Sidem Nr	OE Number
Mercedes	49976	204 330 43 11
Track Control Arm	49977	204 330 44 11
	49978	204 330 19 11
	49979	204 330 20 11

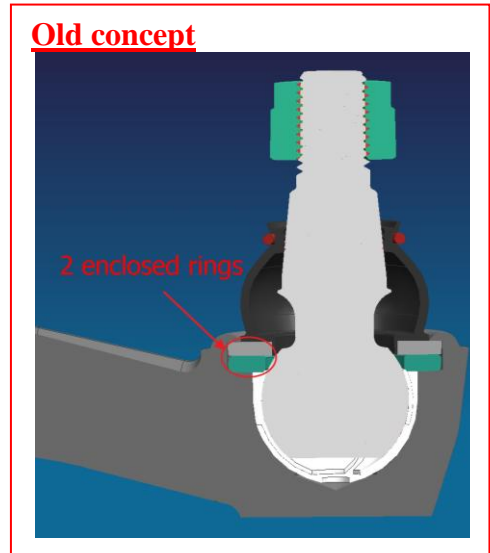
- Premature play on ball-joint.

- Due to the 2 enclosed rings that close the assembly, tolerances cannot be kept as small.
- This can cause instability-play in extreme conditions.

- Classic design with only 1 enclosed ring where the DC is attached on a classical way
- So the closing ring is in direct contact with the insert what offers a more stable-rigid assembly.
